LIGO-T1400160-v8

H1 Optical Lever Inspection and Checklist

H1 Optical Lever Inspection and Checklist

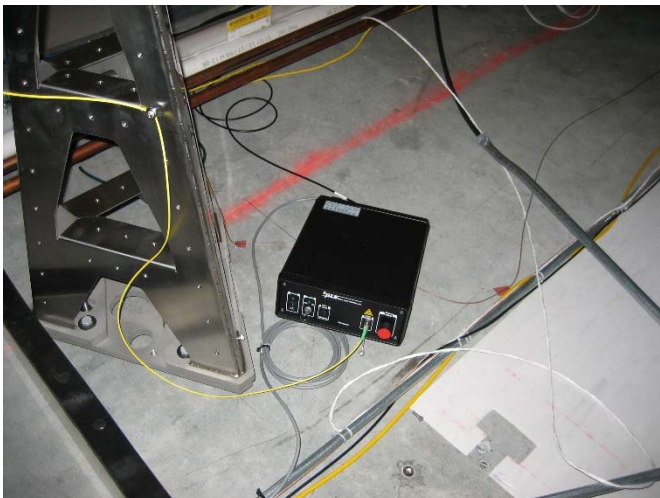
1. Needs laser mounting rack to get it off of the ground and needs to include the DC to DC converter. Needs to be designed or bought. (This may require more than one configuration as each installation has unique requirements).

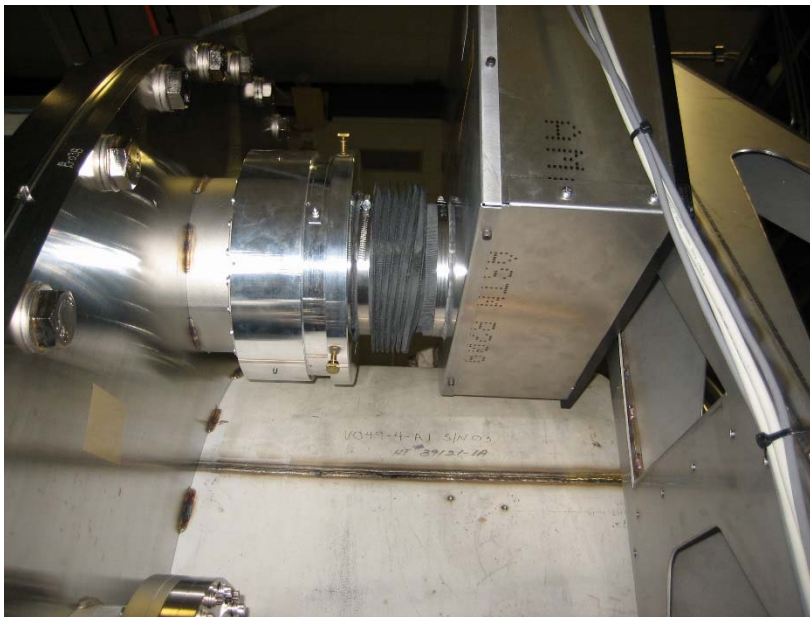
1. Pylon needs to be raised and grouted.
2. Needs proper grommet.

3. Modify bellows to provide for a more mechanically compliant connection.
4. Needs new proper sized grommet to prevent laser light exposure from the enclosure.
5. Remove paper wrap on laser boxes.
6. Remove extraneous equipment and trash from piers. Add labels to piers indicating 'No Step' and 'No Touch'

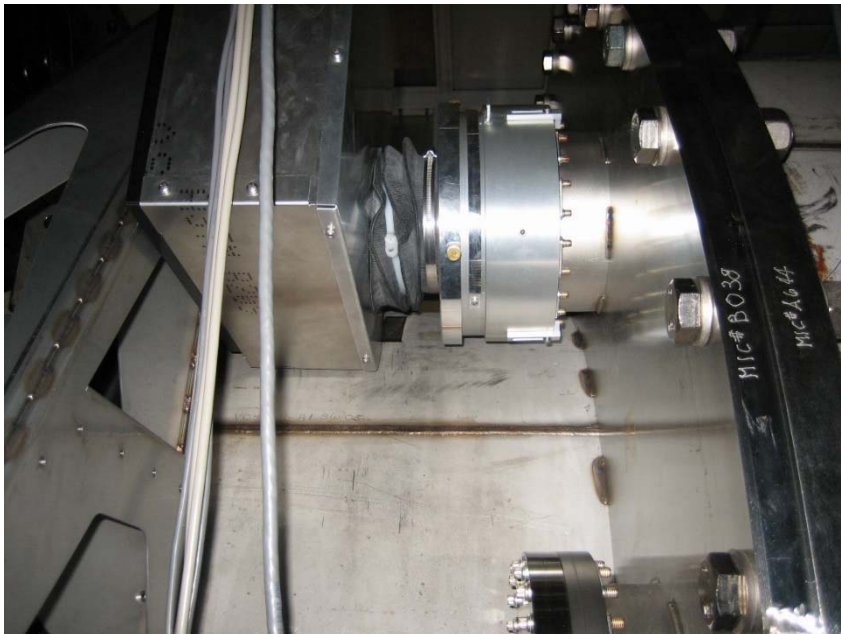
1. Needs laser mounting rack to get it off of the ground.
2. Needs to be designed or bought. (This may require more than one configuration as each installation has unique requirements).
3. Laser needs to have the 18vdc to 5vdc daughter card installed outside of laser enclosure (heat issue).
4. Some cables need to be labeled.
5. Note: No ice chest enclosure (not aLIGO req).
6. Reduced RPM on laser enclosure fan (add diodes) - Yes___, No___, ? X
7. Bench setting of mode hop free range – Yes___, No X

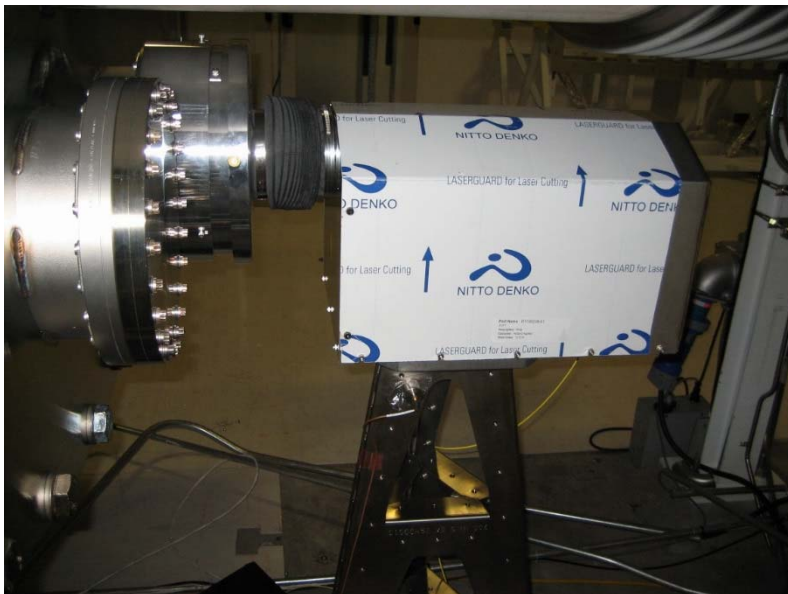
1. Need lead dampeners with enclosure.
2. Modify bellows to provide for a more mechanically compliant connection.
3. Pylon needs to be grouted.
4. Remove paper cover on laser boxes.

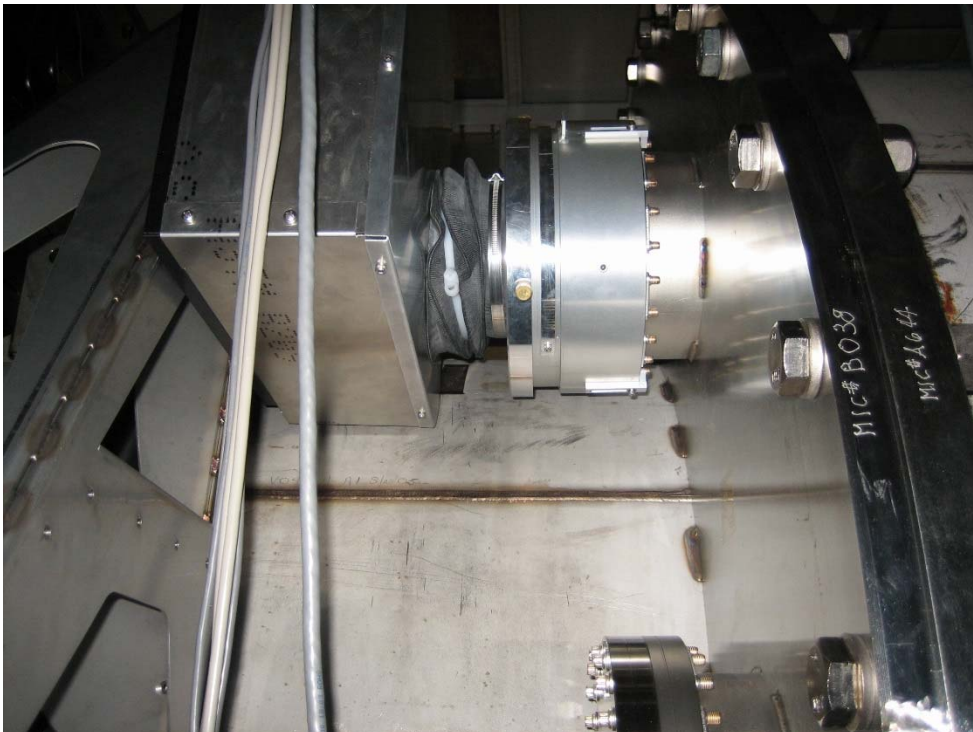
1. Needs laser mounting rack to get it off of the ground. Needs to be designed or bought. (This may require more than one configuration as each installation has unique requirements).
2. Laser needs to have the 18vdc to 5vdc daughter card installed outside of laser enclosure (heat issue).
3. Note: No ice chest enclosure (not aLIGO req).
4. Reduced RPM on laser enclosure fan (add diodes) - Yes___, No___, ? X
5. Bench setting of mode hop free range – Yes___, No X

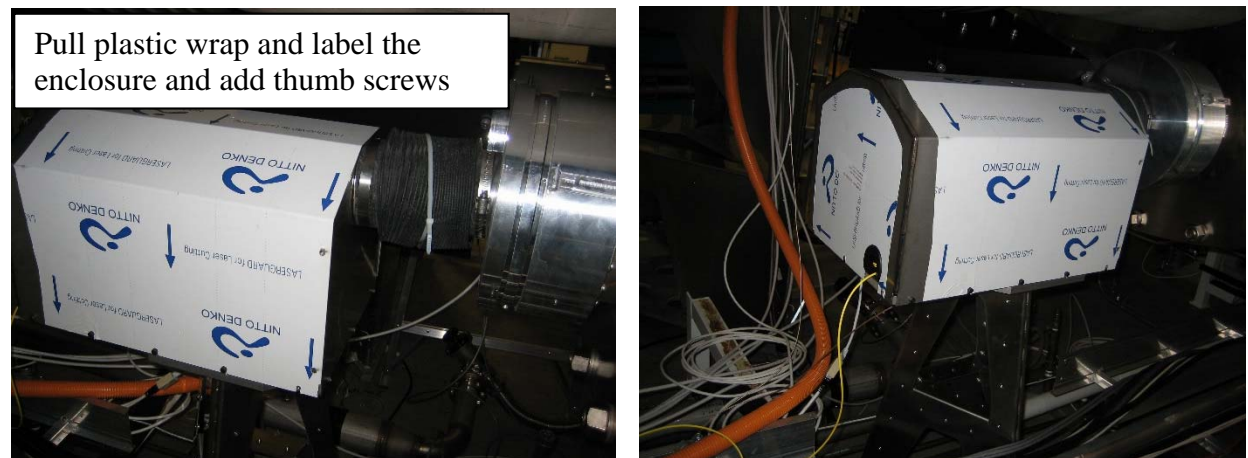
1. Need lead dampeners with enclosure.
2. Modify bellows to provide for a more mechanically compliant connection.
3. Remove paper cover on laser boxes.
4. Remove paper cover on laser boxes.
5. Pylon needs to be grouted.
6. P-Cal complete and in final configuration.
7. Remove extraneous equipment and trash from piers. Add labels to piers indicating 'No Step' and 'No Touch'.

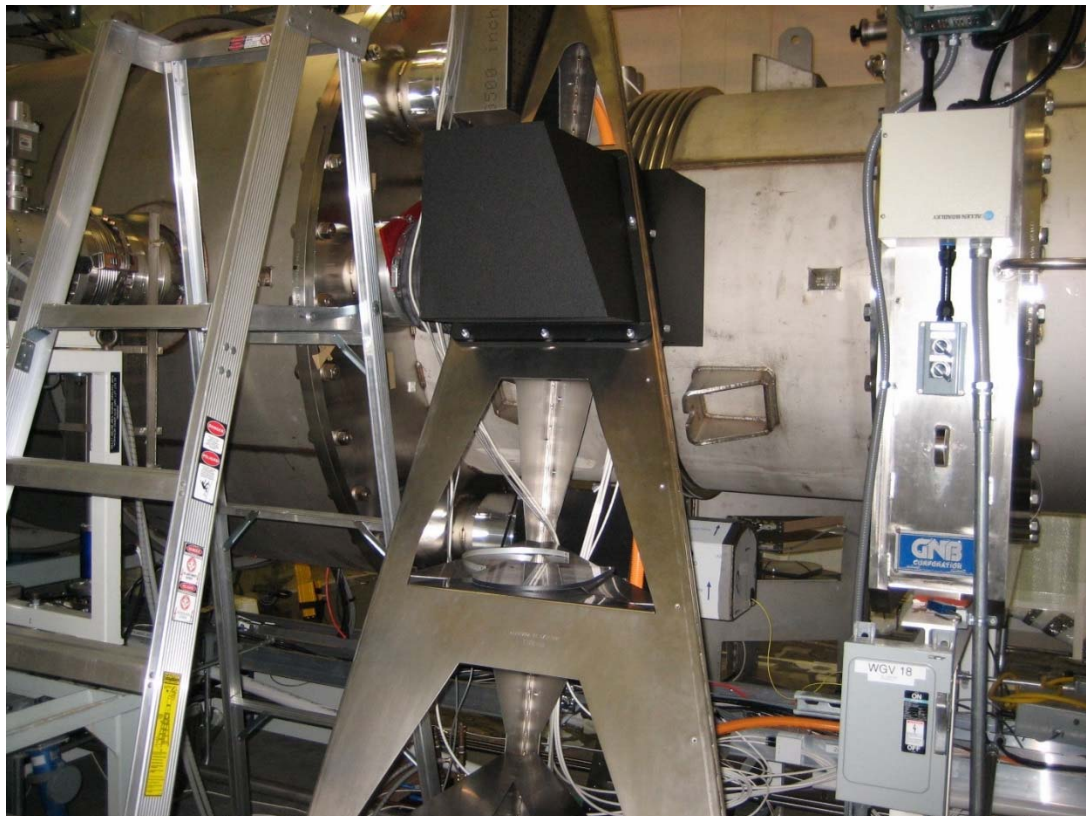
1. The fiber must be rolled into a larger loop and secured to protect it.

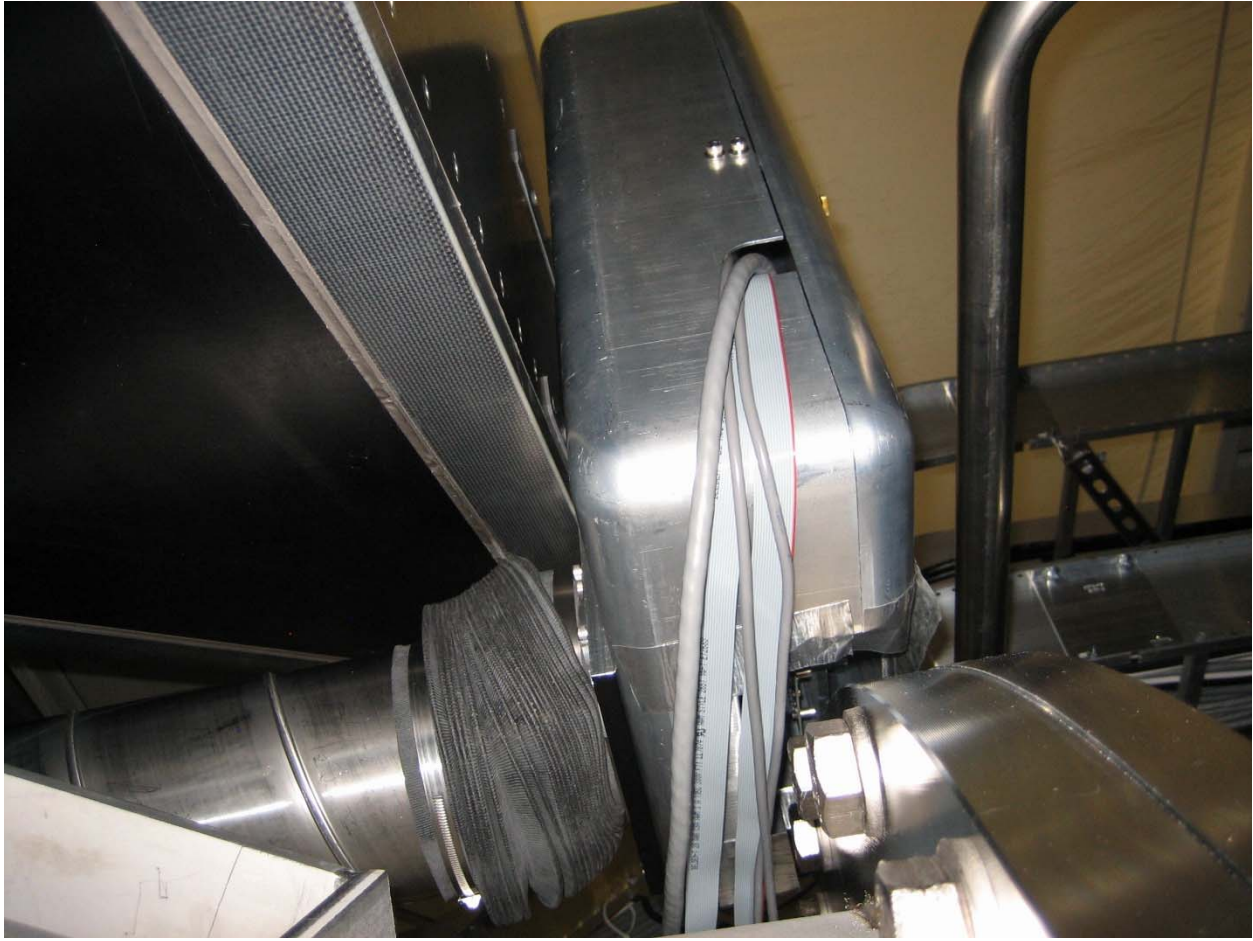
2. Laser needs to have the 18vdc to 5vdc daughter card installed outside of laser enclosure (heat issue).
3. Note: No ice chest enclosure. (not an aLIGO req).
4. Reduced RPM on laser enclosure fan (add diodes) - Yes___, No___,? X
5. Bench setting of mode hop free range – Yes, X, No ___

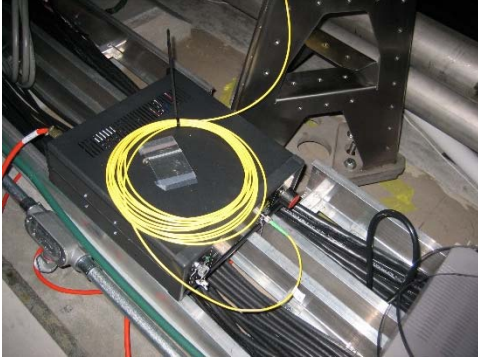
1. Needs laser mounting rack to get it off of the ground. Needs to be designed or bought. (This may require more than one configuration as each installation has unique requirements).

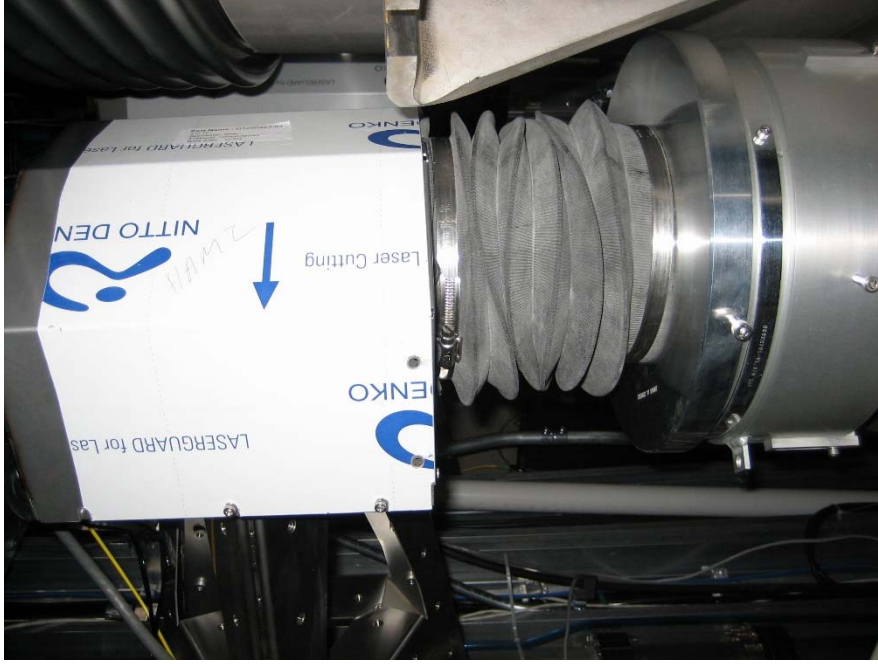
4. We need to raise this pylon to reduce the amount of stretch on the bellow and reduce the seismic isolation coupling.
5. Remove extraneous equipment and trash from piers. Add labels to piers indicating 'No Step' and 'No Touch'.
6. Beam pipe needs some support (needs a design).
7. Concern the large area of the support pier will act as a sounding board and conduct acoustical signals to the sensor head.
8. Support light pipe.

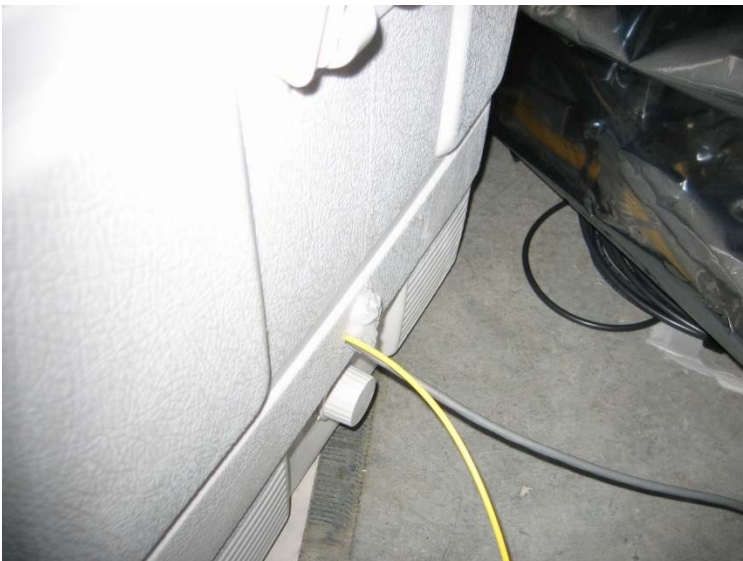
2. Laser needs to have the 18vdc to 5vdc daughter card installed outside of laser enclosure (heat issue).
3. Note: Has ice chest enclosure (not aLIGO req).
4. Binary output modulator installed and gains set.

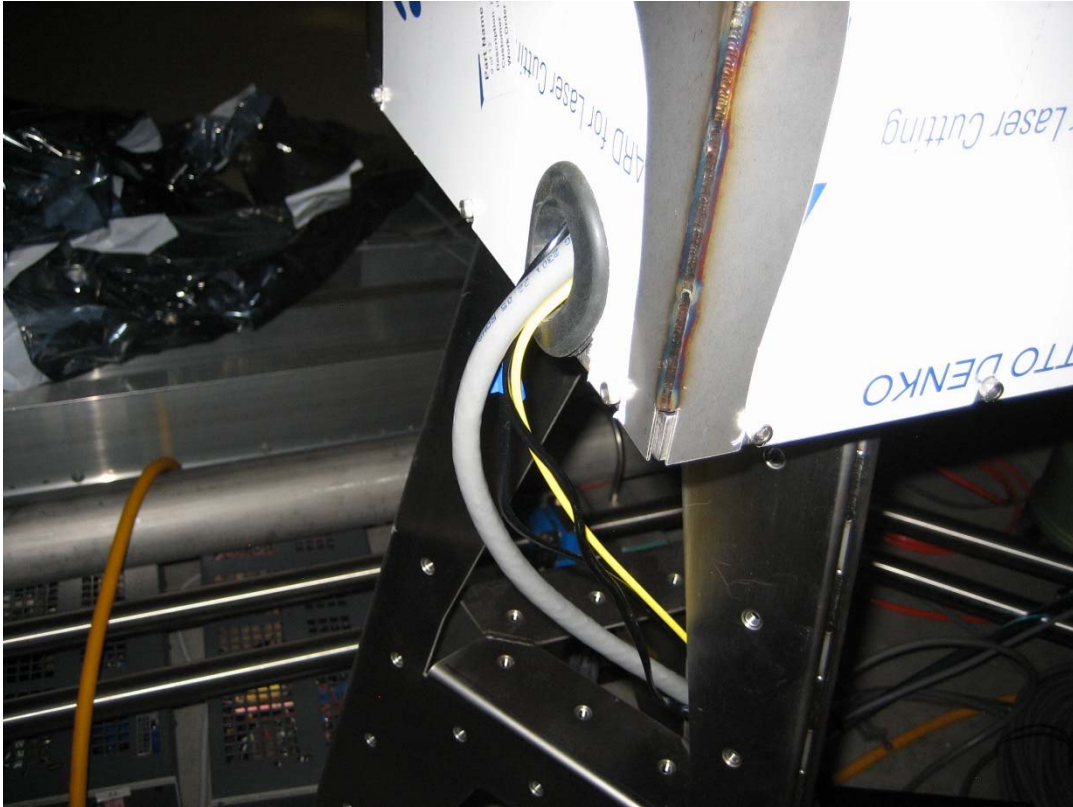
1. Remove extraneous equipment and trash from piers. Add labels to piers indicating 'No Step' and 'No Touch'.
2. Grout, add grommet
